## **Addendum Number One**

**Date of Issue:** 02/22/13

**Project:** USC Preston College Bathroom and Flooring Renovations  
Project Number: H27-6086-SG

**B2**

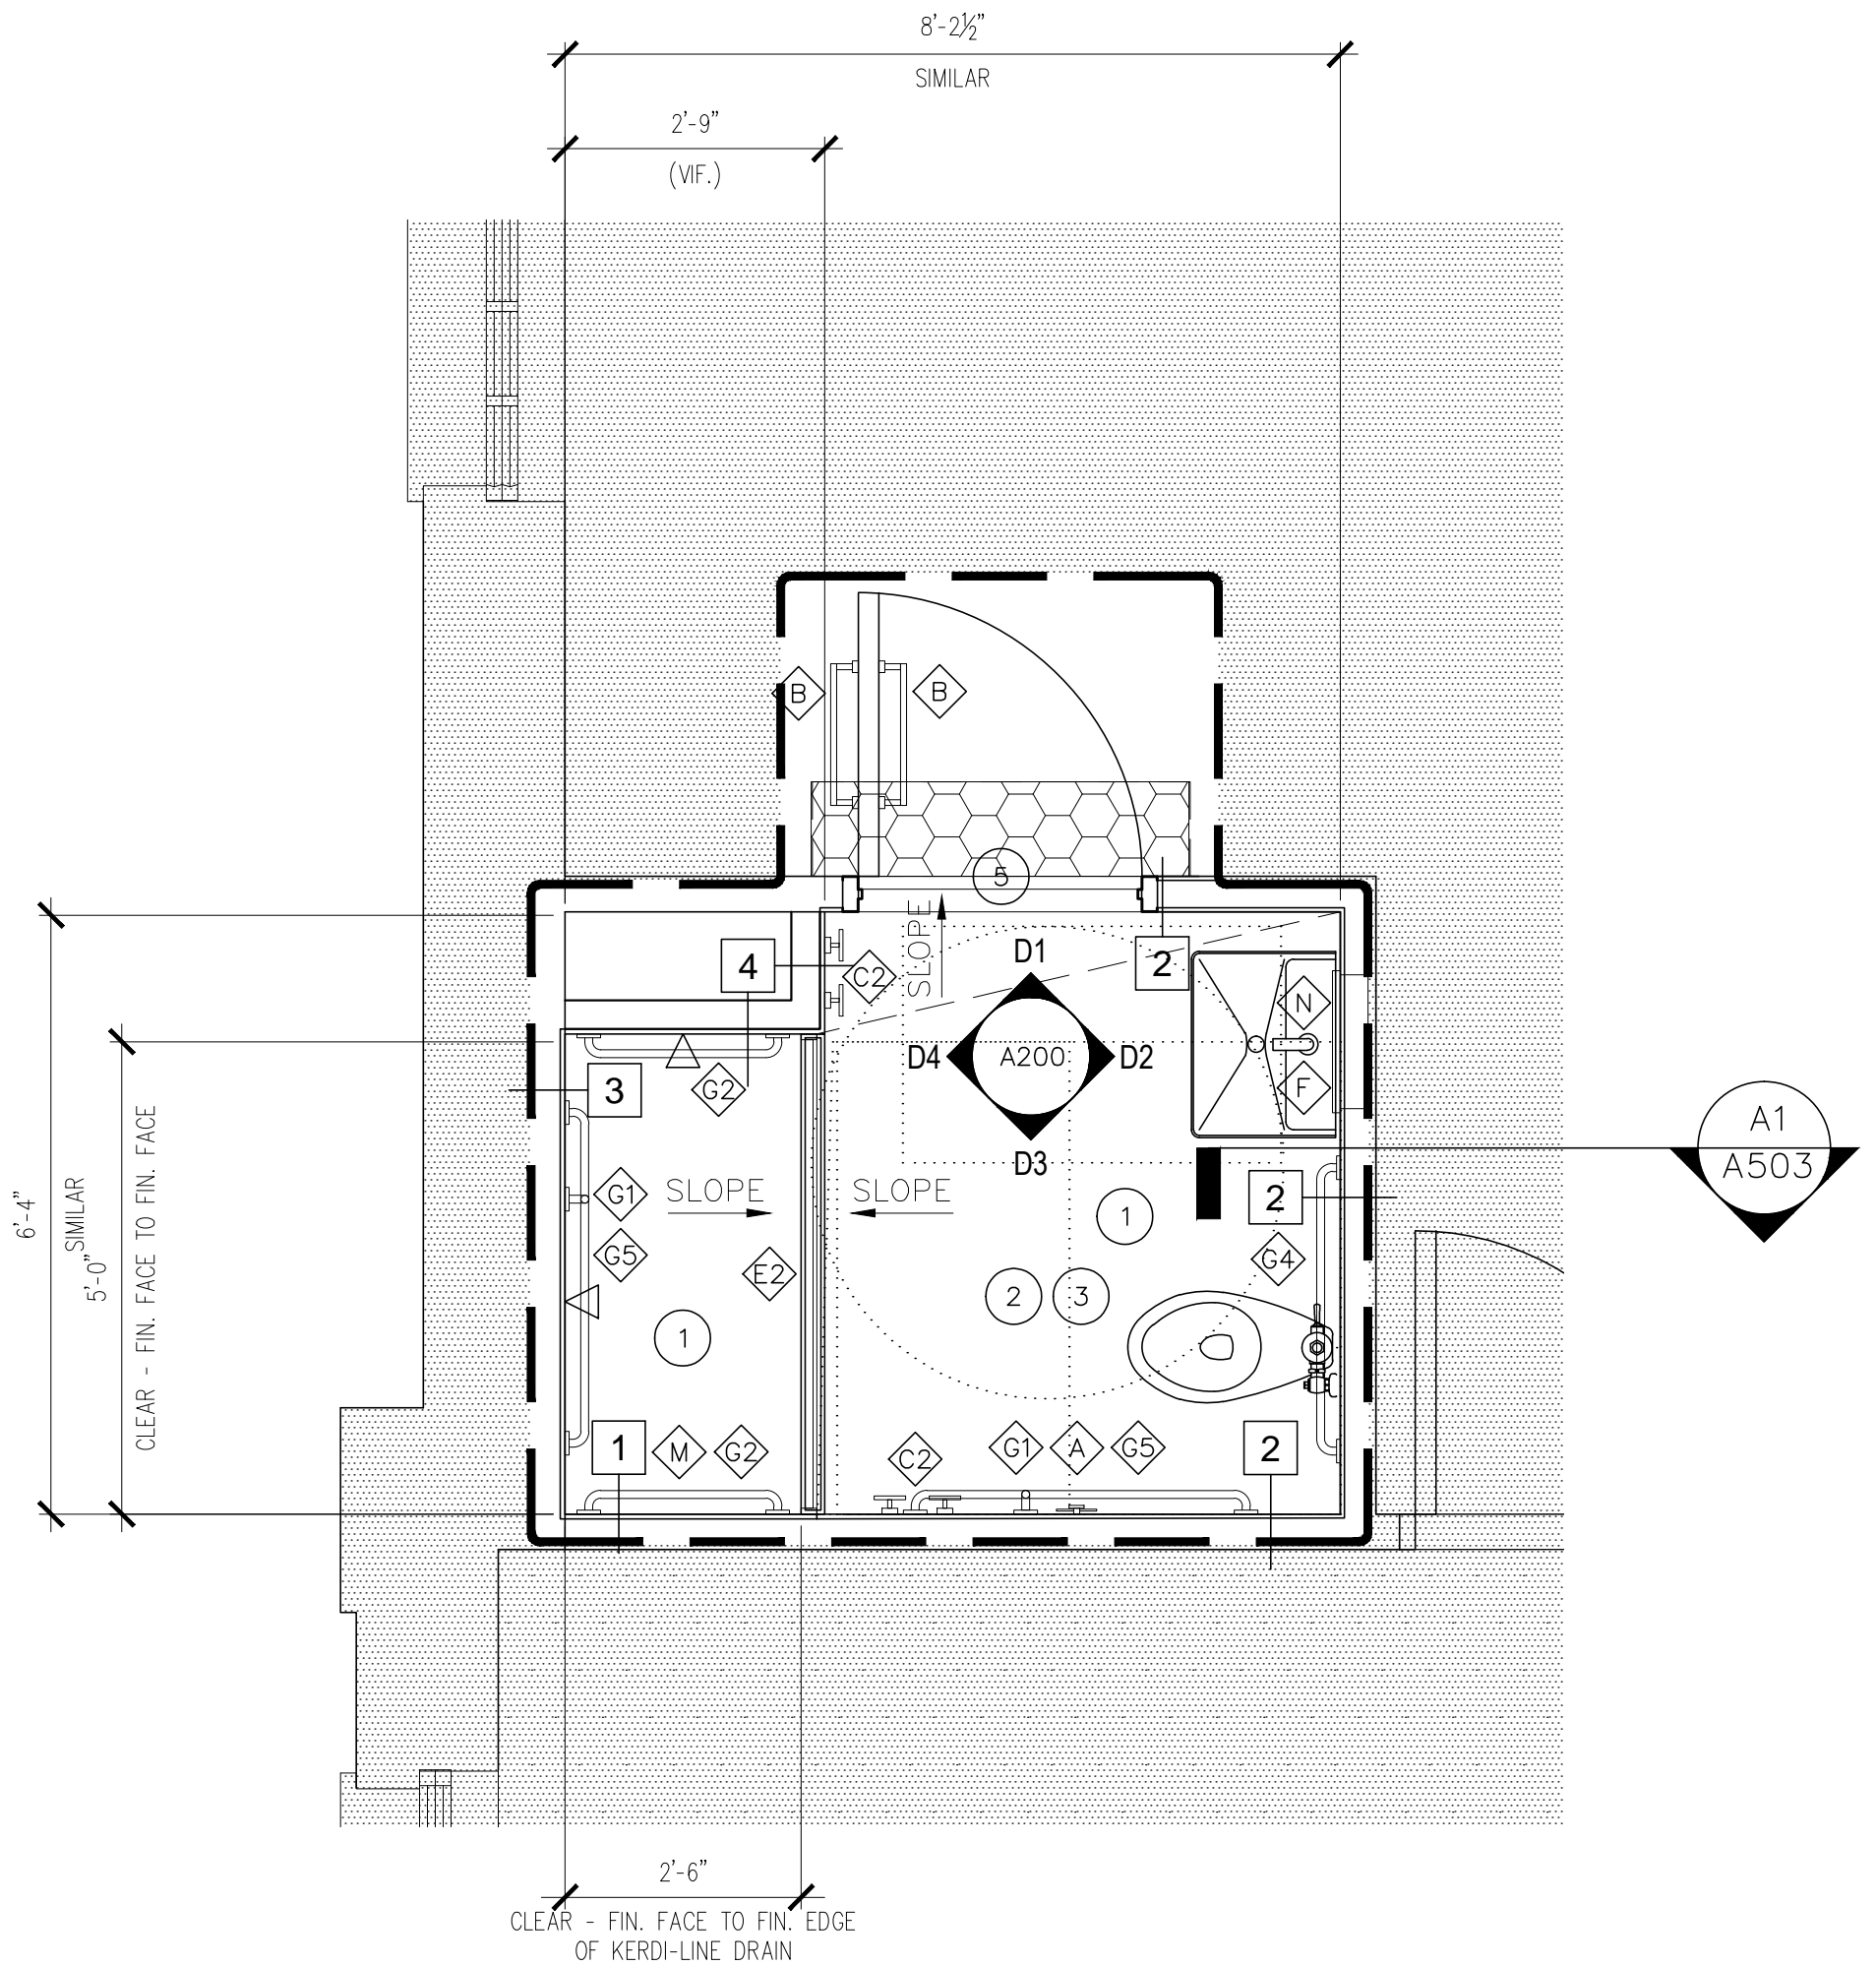
10. **SHEET AD112 / A1** Add keyed note 8.
11. **SHEET A101** Remove and replace with enclosed sheet A101.
12. **SHEET A111** Delete B2/A111 and add Sketch SK-A-002.

**A3**

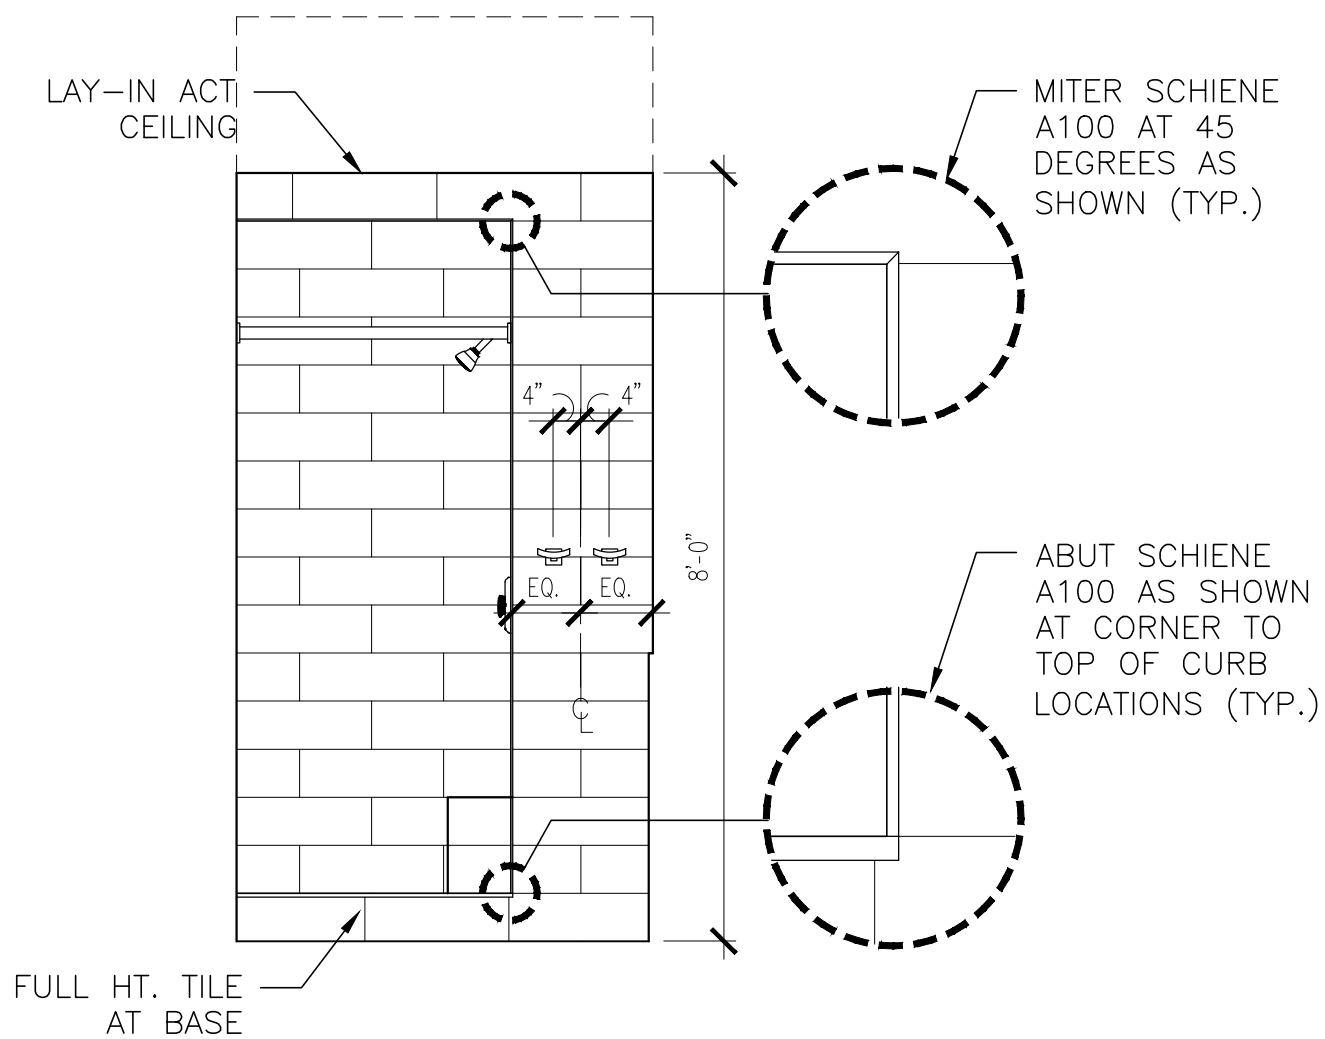
16. **SHEET A132 / A1** Add keyed note 1.
17. **SHEET A132 / B2** Add keyed note 1.
18. **SHEET A200** Delete A3/A200 and add Sketch SK-A-003.

**B1** TYP. ENLARGED SHOWER PLAN

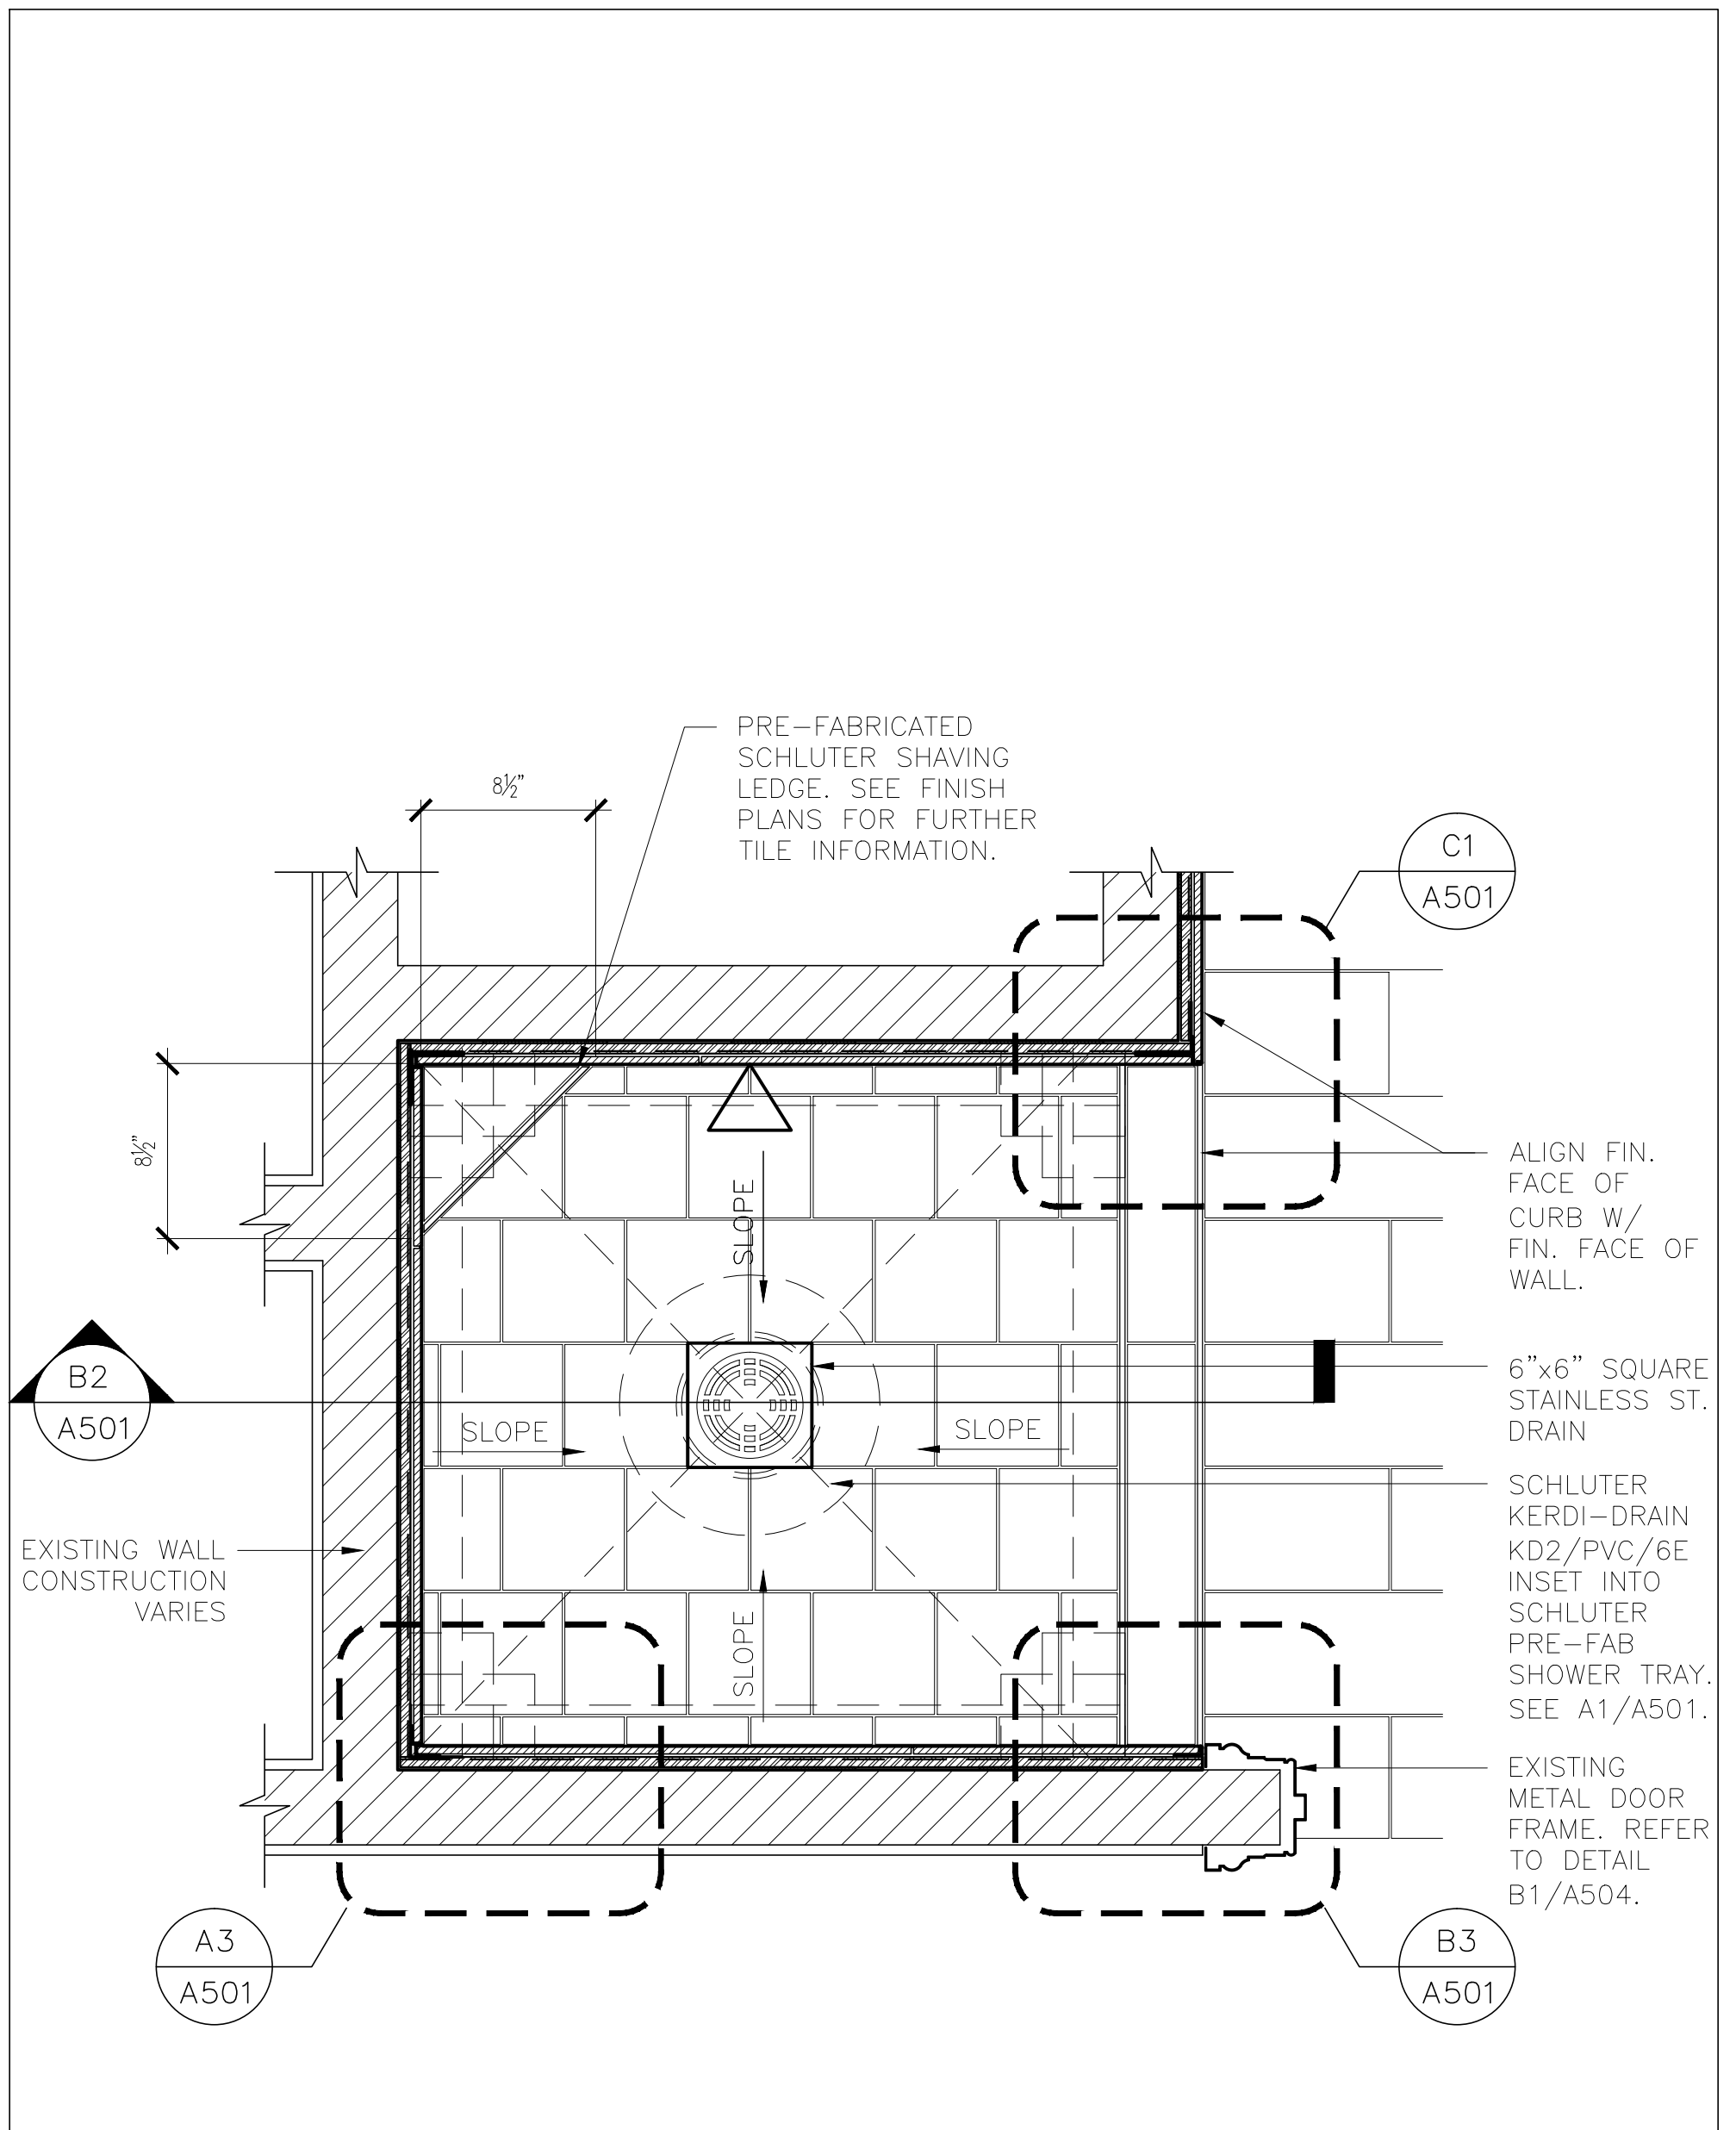
24. **SHEET A500** Delete A1/A500 and add Sketch SK-A-004.
25. **SHEET A501** Delete B1/A501 and add Sketch SK-A-005.
26. **SHEET A502** Remove and replace with enclosed sheet A502.

B2

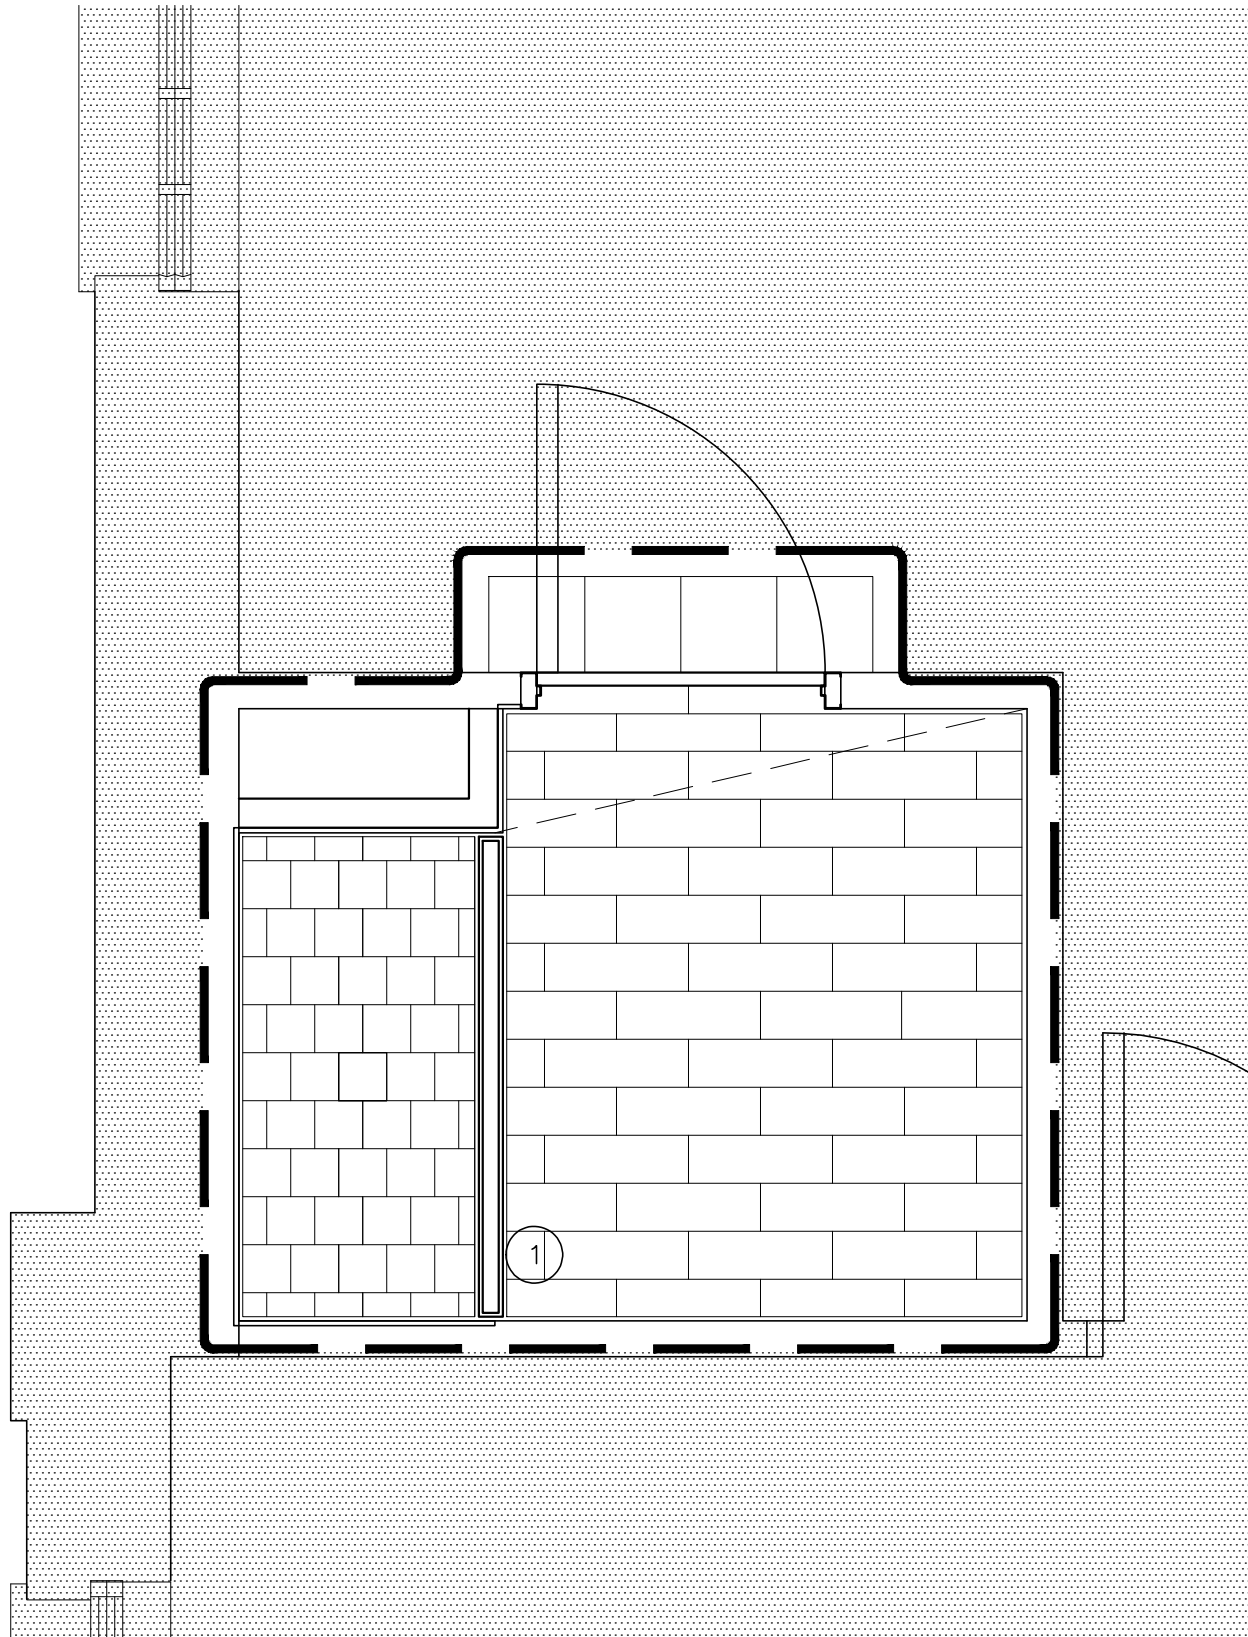
30. **SHEET A601** Add Alternate #1 description and box, to MATCH A602 and A603.
31. **SHEET A711** Delete B1/A711 and add Sketch SK-A-006.
32. **SHEETS A711 and A712 Keyed Finish Note 1** Delete “2” MARBLE THRESHOLD. SEE FINISH SCHEDULE. REFER TO A1/A502.” and add “SCHLUTER KERDI-LINE DRAIN. SEE SHEET A502.”
